## APPENDIX B

Southwark Council had commissioned CONWAY AECOM (CA) to develop proposal to improve walking and cycling between Rye Lane and Nunhead town centres and to enhance the general amenity of the Brayards Road neighbourhood area.

## Summary of the consultation responses

**Q8 Do you support new layout for Kirkwood Road / Kimberley Avenue Junction to give priority to Kirkwood Rd?**

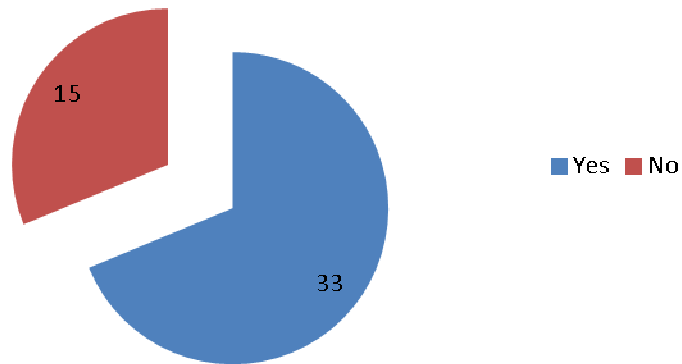
A few individual comments were made:

- This new layout of this junction might encourage vehicles to use Kirkwood Road as a 'through route' in order to avoid traffic on the main roads.
- There is a suggestion of a raised table at this junction.
- Also a suggestion to consider realigning Kimberley Avenue to be perpendicular to Kirkwood Road at the junction.

Southwark Cyclists suggested to give Kirkwood Road priority over Brayards Road east-west movement. Brayards Road is the main east-west route through the area; drivers will not expect to have to give-way to Kirkwood Road traffic. This would create a potential safety issue.

There is also a suggestion to square up the Kimberley Avenue / Kirkwood Road junction and maintain existing priority. The reason to reverse the priority was that traffic on Kimberley Avenue travels around the bend at speed. Giving priority to Kirkwood Road, which has better sightline, will force the Kimberley Avenue traffic to slow down on the approach to the junction. The suggestion to square up the junction have been investigated, it will mean the loss of a mature tree, hence was not progressed.
